Interactive comment on “Simulation of storm surge inundation under different typhoon intensity scenarios: Case study of Pingyang County, China” by Xianwu Shi et al.

Xianwu Shi et al.

Received and published: 19 June 2020

Fig. 1. The relation between the central pressure difference (ΔP) and the radius of maximum wind speed (R_{max})

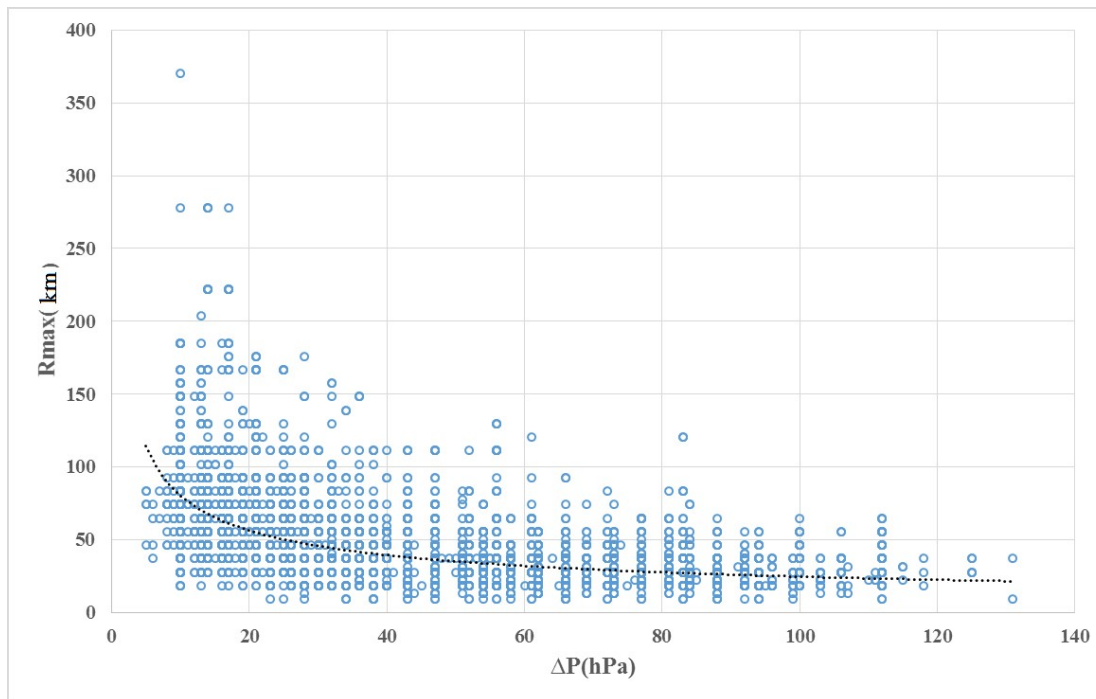
3. Additionally, the typhoon size is inversely proportional to the typhoon intensity if the Jelesnianski typhoon model was used. This phenomenon should be discussed in the manuscript. Response: Thanks for your suggestion. The typhoon size has a strong connection to the typhoon intensity. As described above, radius of maximum wind speed was used to indicate the “size” of the typhoon. Collecting the historical radius of maximum wind speed data measured in the northwest Pacific hurricane records (2001-2016) from the Joint Typhoon Warning Center (Wang et al, 2020), it can be seen that the radius of maximum wind speed is inversely proportional to the central pressure difference. In this study, the empirical relationship below was used to calculate the value of Rmax: $R=R_0-0.4(P_0-900)+0.01(P_0-900)^2$ where P_0 is the central air pressure (hPa), R is the radius of maximum wind speed, and R_0 is an empirical constant. The recommended value is 40. The Rmax and typhoon intensity also presents a negative correlation in this formula.
